## Addendum #3

**Project Name:** Cattle National Bank & Trust - Fallbrook  
6550 Merchant Drive  
**Project No.:** 12054  
**Issued:** May 09, 2013  
**Bid Date:** 2:00 pm, CDT May 14, 2013

**F9 INTERIOR ELEVATION**  
SCALE: 1/4" = 1'-0"

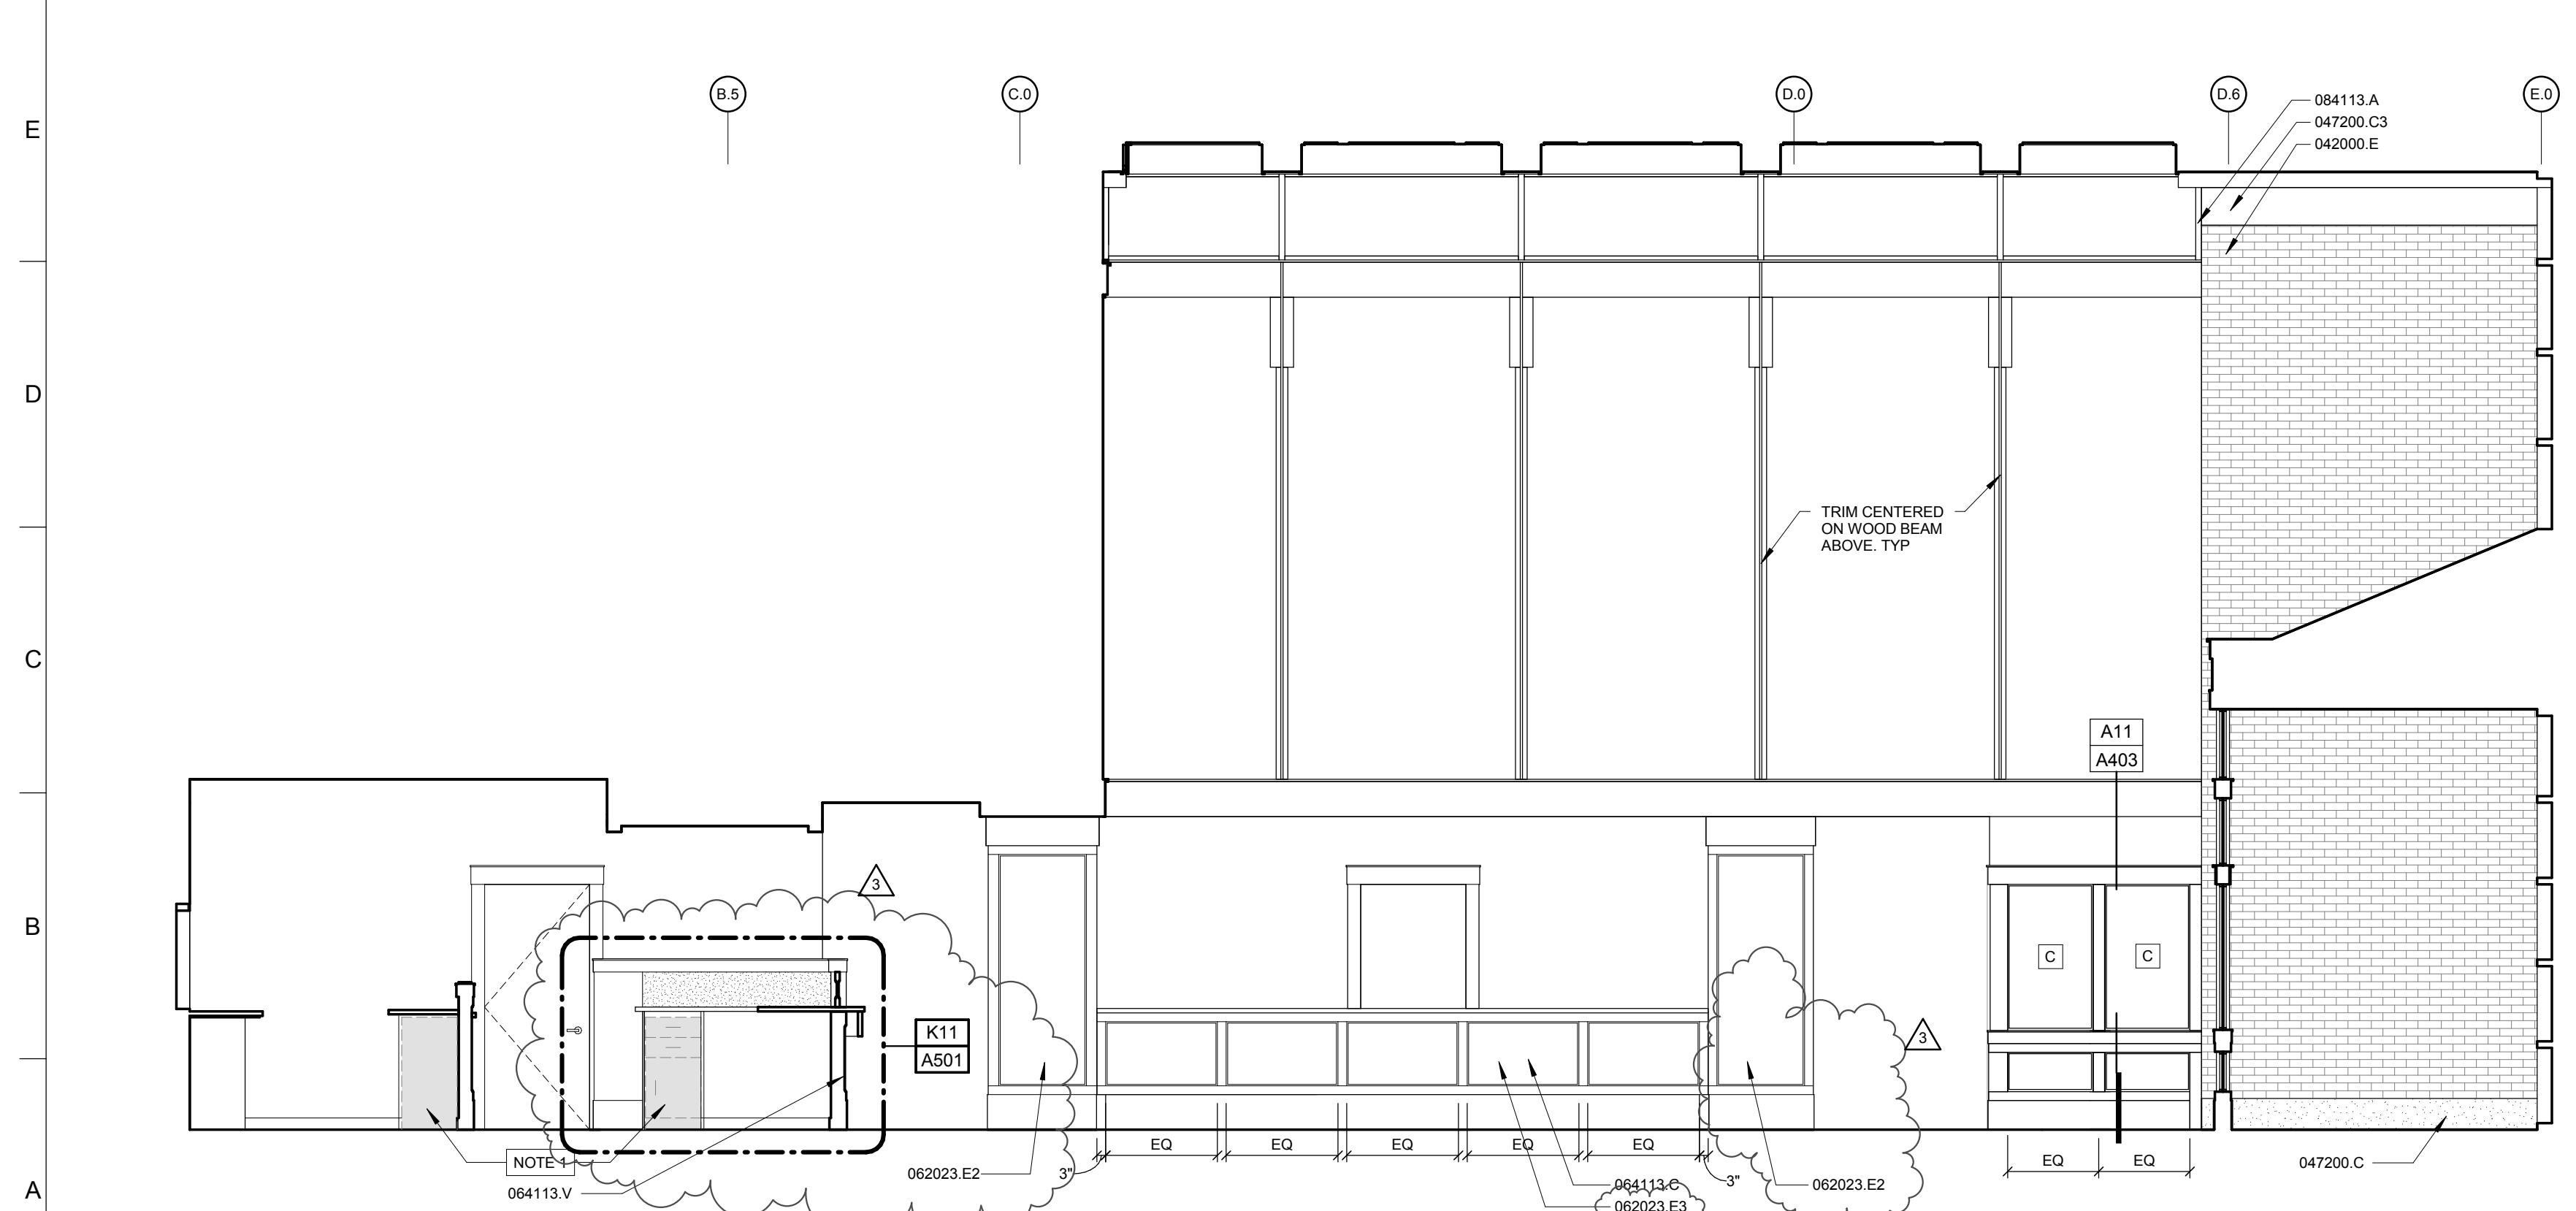
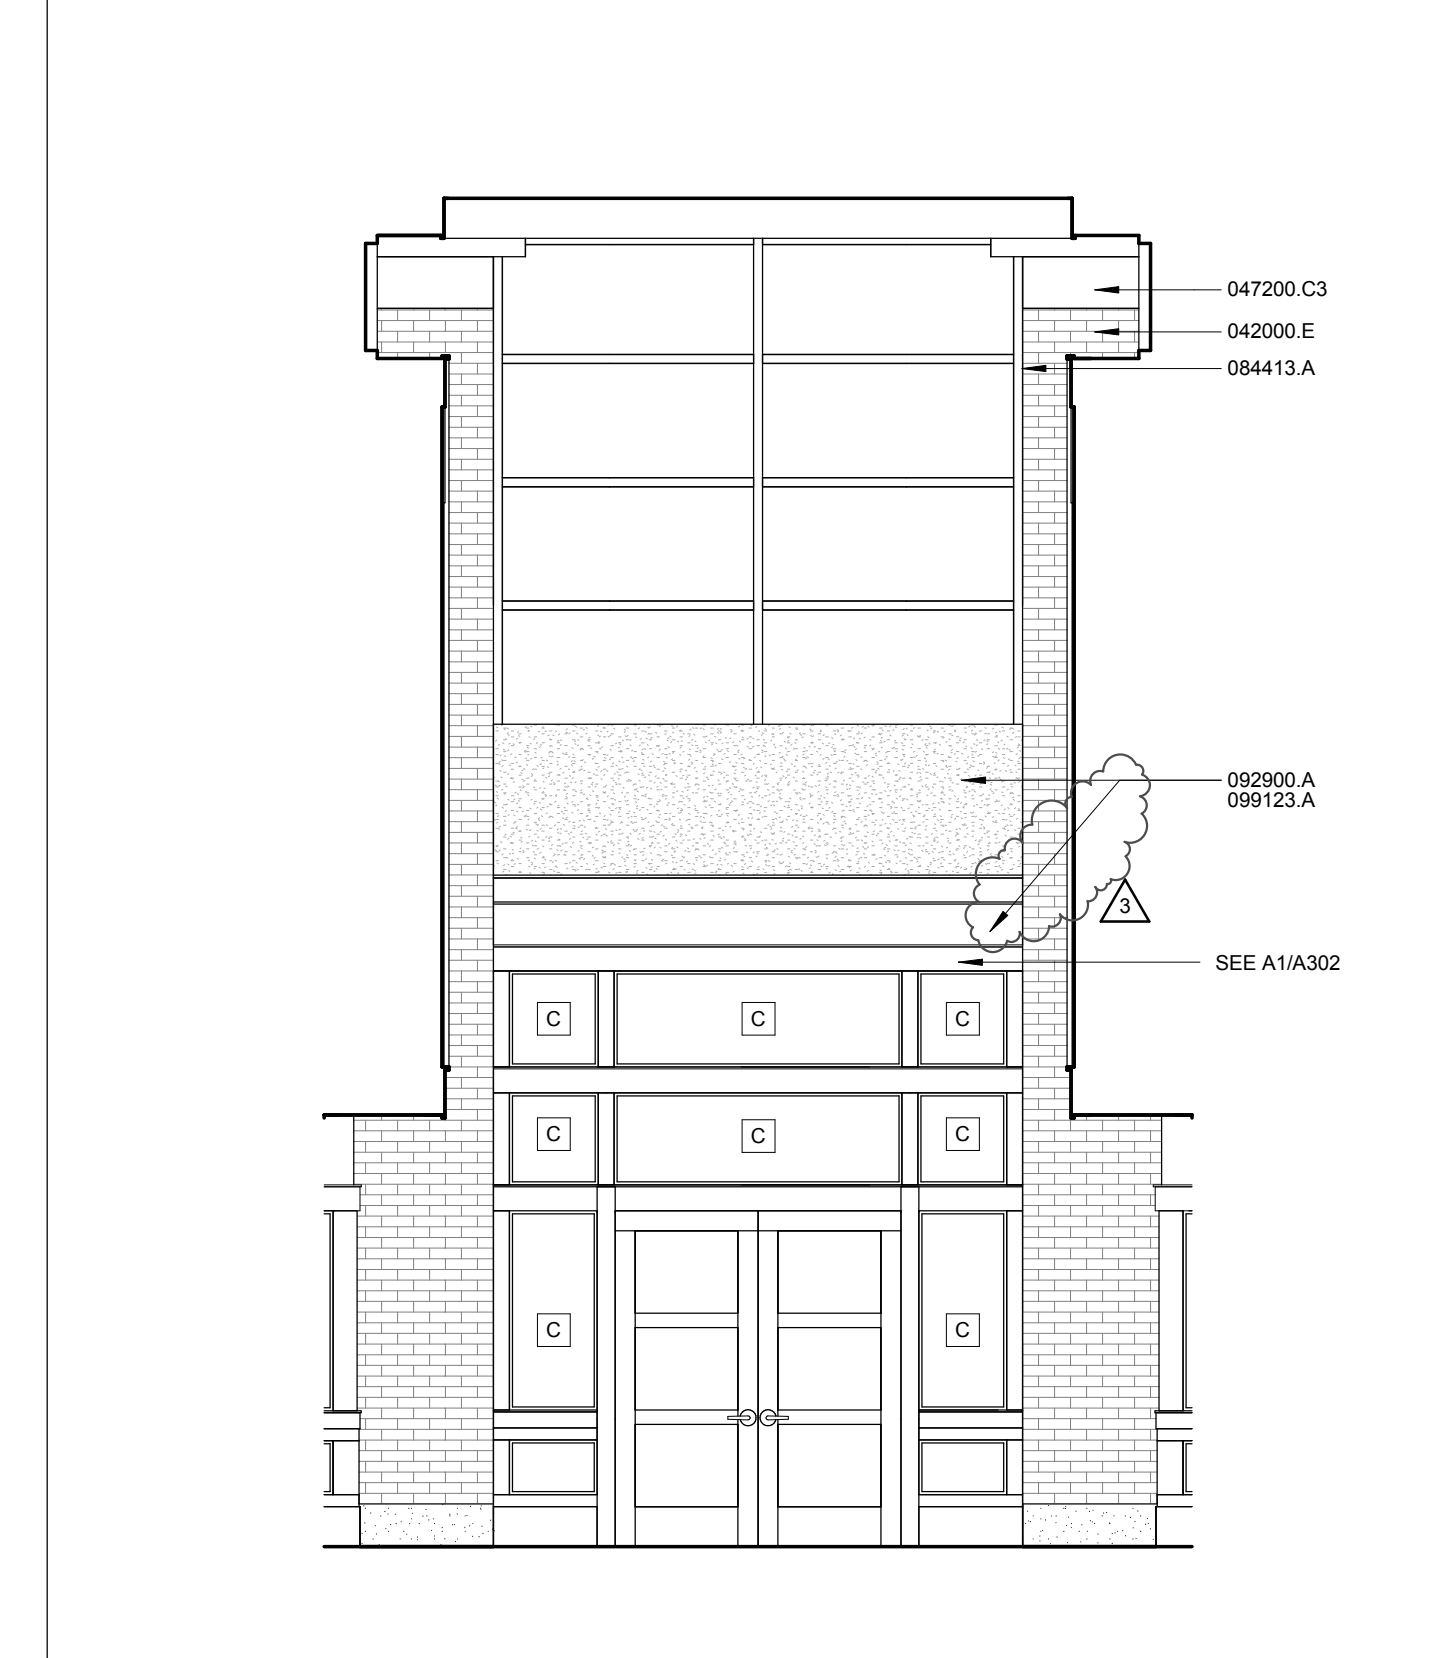
- a. F1/A503: Added keynote 062023.E2 to clarify scope. Added additional keynotes and callout tags to existing drawings. Refer to Revised Sheet A503.
- b. F9/A503: Added keynote 062023.E2 to clarify scope. Revised reception desk section and back counter section. Added additional keynotes and dimensions. Refer to Revised Sheet A503.
- c. A1/A503: Added keynote 062023.E3 and 062023.E2 to clarify scope of woodwork. Added callout tag of existing drawing, removed section tags at wood columns. Refer to Revised Sheet A503.
- d. A9/A503: Added keynote. Refer to Revised Sheet A503.
